SERVICE BULLETIN

AMERICAN HONDA MOTOR CO., INC. MOTORCYCLE SERVICE DEPARTMENT

1980 CBX IGNITION TIMING ADVANCER

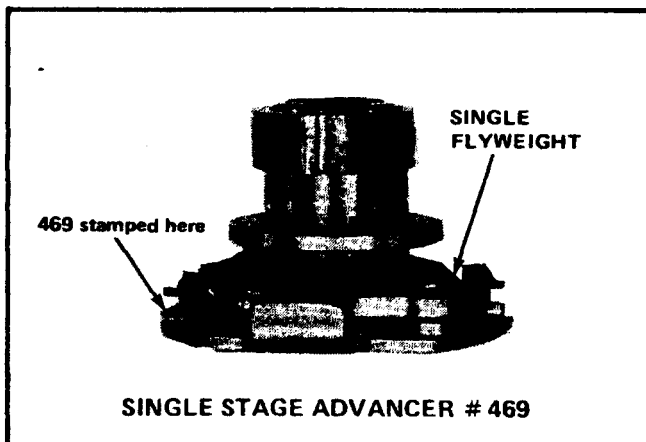
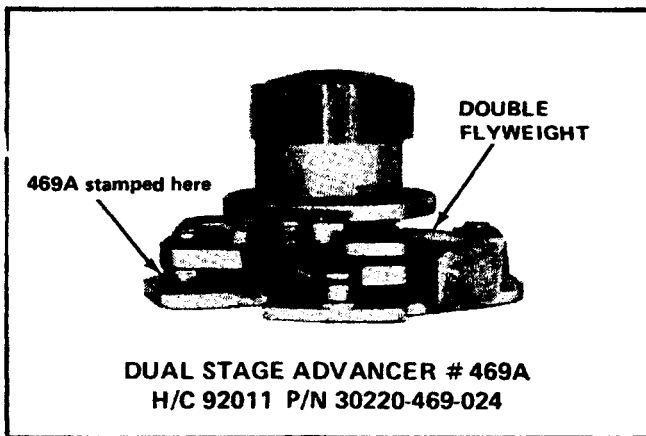
Order a dual stage ignition timing advancer from parts stock for each CBX you receive within the engine number range given below. Install the dual stage advancer before delivering any affected machine to the customer. If this is not possible, install the advancer at the scheduled break-in maintenance. After engine number SC03E-2001773 the factory began installing the dual stage advancers on all units.

1. Remove the single stage advancer from all affected units. Refer to the procedure in the CBX Shop Manual pages 8-2 and 8-13. Tag the single stage advancers and place them in your warranty parts bin. See the Warranty Policy and Procedures Manual for instructions.

2. Install the dual stage advancer H/C 92011 P/N 30220-469-024. Inspect and adjust ignition timing following the static ignition timing procedure (engine not running) on page 3-5 in the CBX Shop Manual.

NOTE: If you check spark advance with the engine running you must use a degree wheel. On the '80 model CBX (with the dual stage advancer) the advance specification is 31° at 5,600 to 7,000 rpm. The specification 31° at 8,000 rpm as shown on the degree wheel (H/C 71955 T/N 07974-4220000 or H/C 84396 T/N 07974-4220001) is for the '79 CBX only.
